CITY OF SALEM Staff Report

File #: 23-431

Public Hearing for a Salem Transportation System Plan Amendment
Relating to Colorado Drive NW and Landaggard Drive NW

TRANSPORTATION SYSTEM PLAN (TSP) AMENDMENT CA23-05 LANDAGGARD AND COLORADO DRIVES NW

EXHIBIT MAP

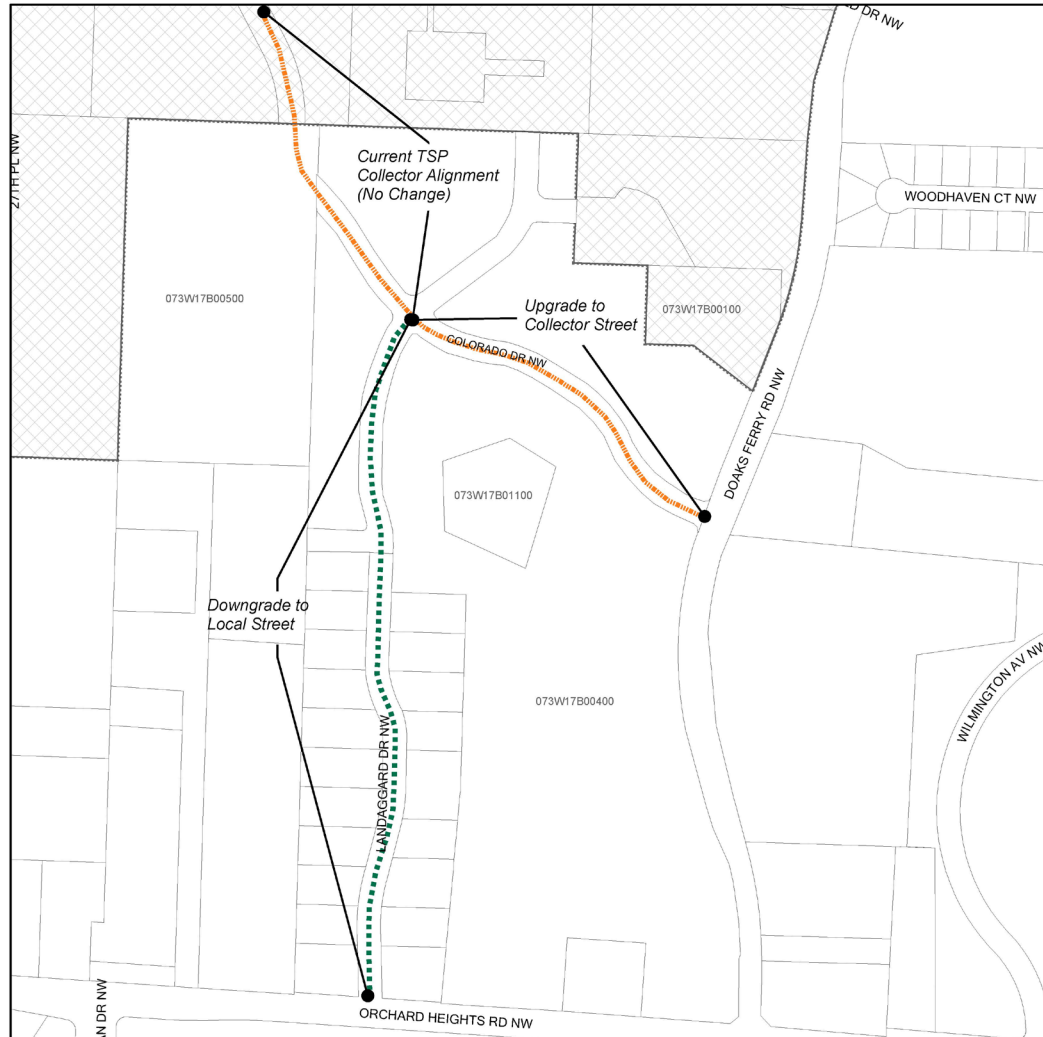
Support linking Colorado Drive to either Orchard Heights Road or Doaks Ferry Road so long as the actual alignment of Colorado Drive maintains an 8% or less grade and meets ADA rules.

The proposed Colorado Drive alignment is **a 12% grade that is greater than** the 8% maximum required by both Federal ADA rules and Salem Revised Code.

We are asking Council to instruct staff to return a new collector alignment that complies with Salem Revised Code requirements and Federal ADA rules providing safe, reliable, pedestrian movement for our community.

EXHIBIT MAP

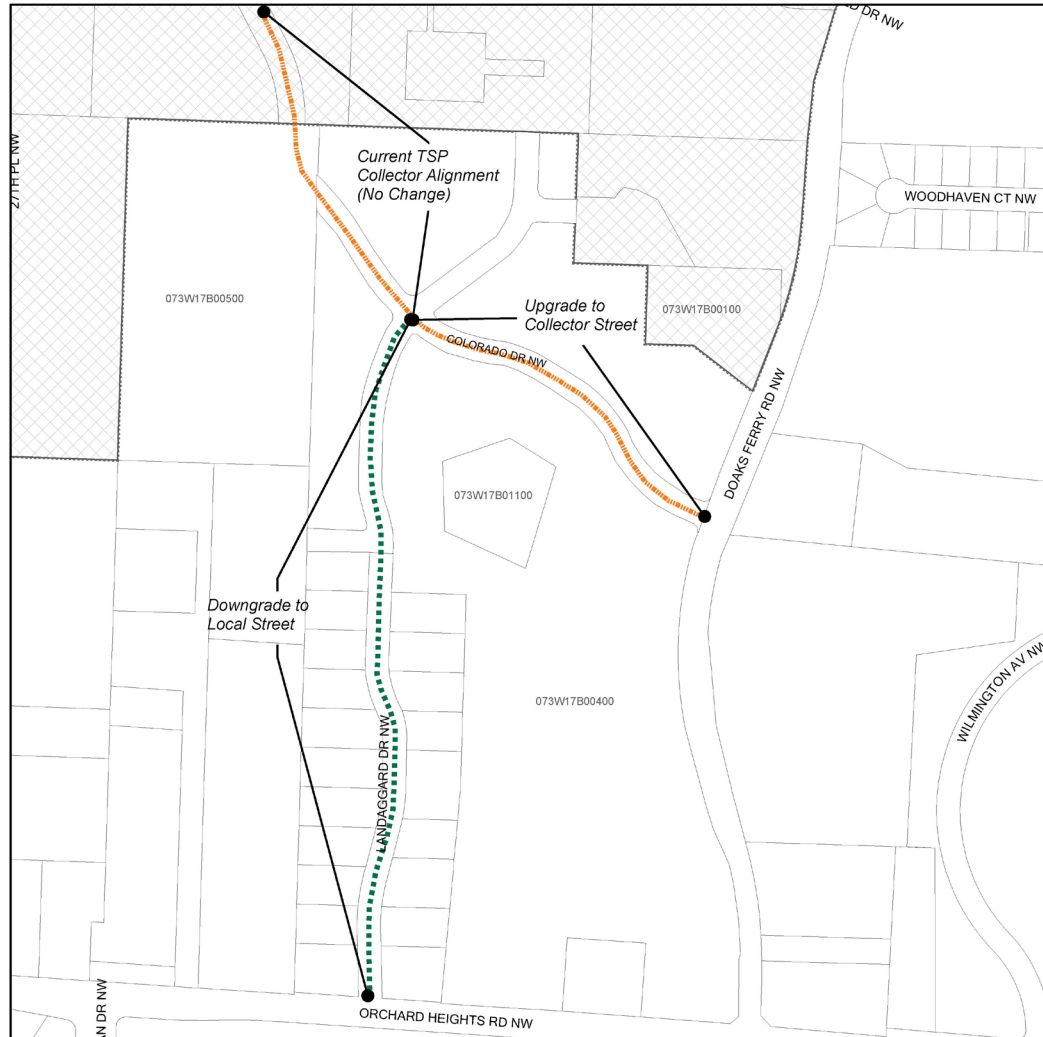
Support linking Colorado Drive to either Orchard Heights Road or Doaks Ferry Road so long as the actual alignment of Colorado Drive maintains an 8% or less grade and meets ADA rules.

The proposed Colorado Drive alignment is **a 12% grade that is greater than** the 8% maximum required by both Federal ADA rules and Salem Revised Code.

We are asking Council to instruct staff to return a new collector alignment that complies with Salem Revised Code requirements and Federal ADA rules providing safe, reliable, pedestrian movement for our community.
